# RENESAS TECHNICAL UPDATE

Product Category	System LSI		Document No.	TN-ECL-A003A/E	Rev.	1.00
Title	EC-1 User's Manual: Hardware Correction and adding notifications about EtherCAT Slave Controller		Information Category	Technical Notification		
Applicable Product	EC-1	Lot No.	Reference Document	EC-1 User's Manual: Hardware Rev.1.10 R01UH0691EJ0110 Rev.1.10		
		All lots

Correction and adding notification about EtherCAT Slave Controller.

**Figure 22.3 Configuration of Reset Circuit of EtherCAT Slave Controller**

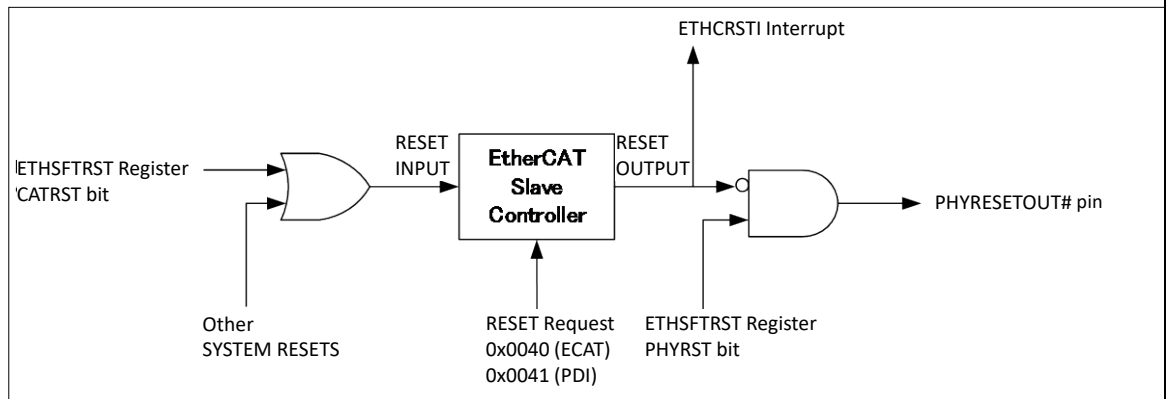
[Current description] No description.

[Correct description] Add the description in below.

The configuration of Reset Circuit of ESC is shown in Figure 22.3. When Reset Request (0040h) by ECAT or Reset Request (0041h) by PDI have been received, ESC will stop and RESET pin output from ESC becomes "1". The RESET pin output from ESC will cause the PHYRESETOUT# pin to be low, then it will reset the Ethernet PHY that connected outside. And ETHCRSTI interrupt is generated.

**Figure 22.4 Reset timing of EtherCAT Slave Controller (when reset request by the ECAT/PDI)**

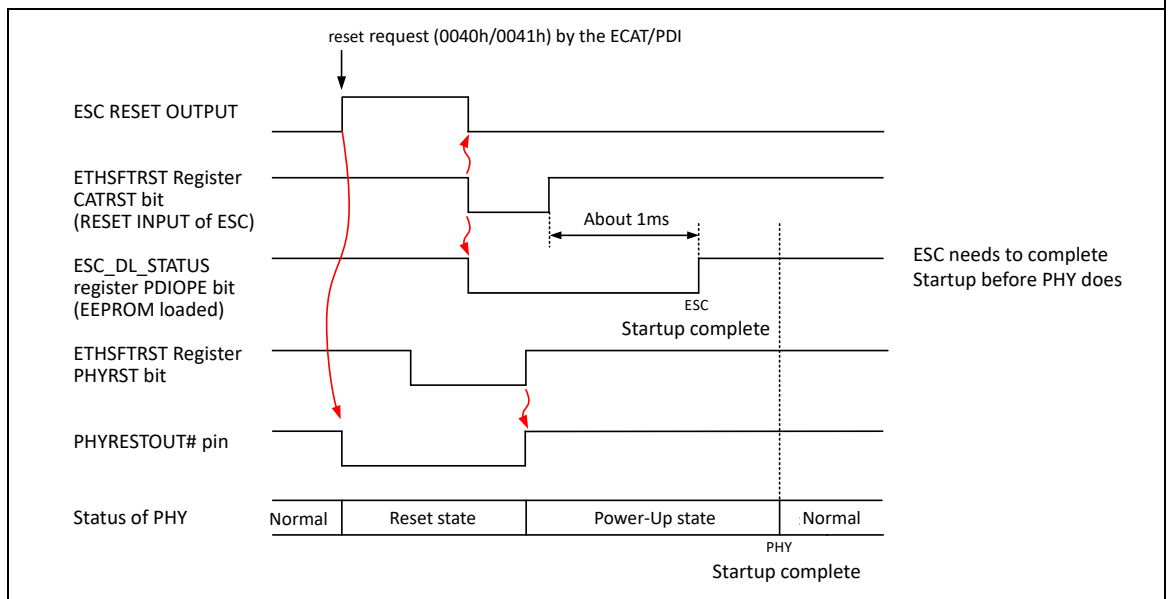
After ETHCRSTI interrupt is detected, it is necessary to switch the CATRST bit in the ETHSFTRST register from "1" to "0" to "1". To be noted, at the time the ESC reset input goes from "1" to "0", the ESC reset output will be "0". At the time when the ESC reset input goes from "0" to "1", the ESC starts restarting and the loading of the EEPROM will be started. The loading of EEPROM will be completed in about 1 ms. Be sure to set the timing of cancelling the reset of the Ethernet PHY, so that the restart of the Ethernet PHY will be after the start of ESC is completed. The timing chart is shown in Figure 22.4.

**Figure 22.5 Reset timing of EtherCAT Slave Controller (when reset by the CATRST bit of ETHSFTRST)**

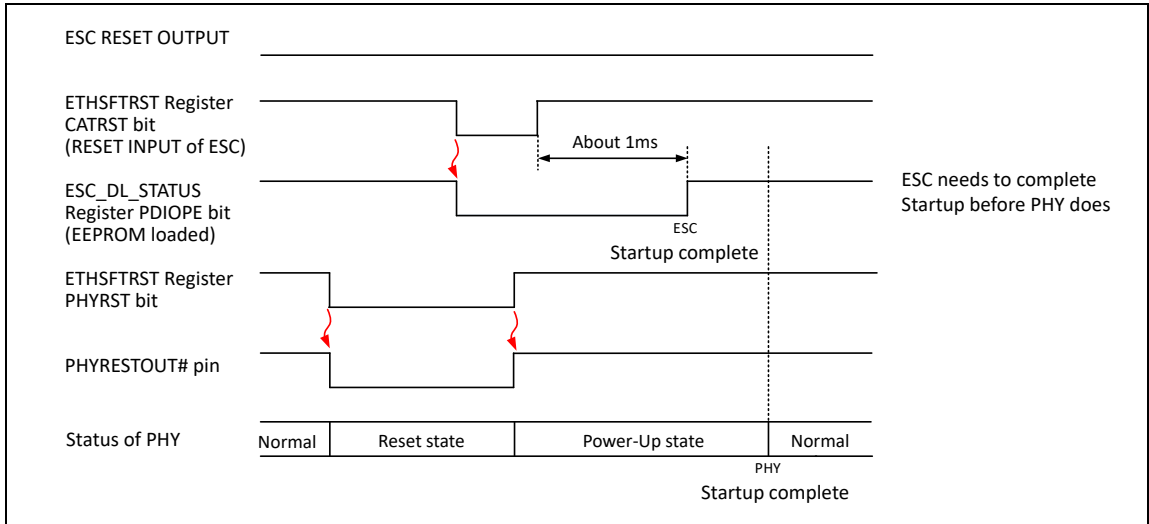
It is also possible to reset the ESC with the CATRST bit in the ETHSFTRST register, not by the ECAT/PDI reset request (0040h/0041h). In this case, since the PHYRESETOUT# pin does not automatically go low, set the Ethernet PHY to the reset state beforehand by the PHYRST bit in the ETHSFTRST register. The timing chart is shown in Figure 22.5.
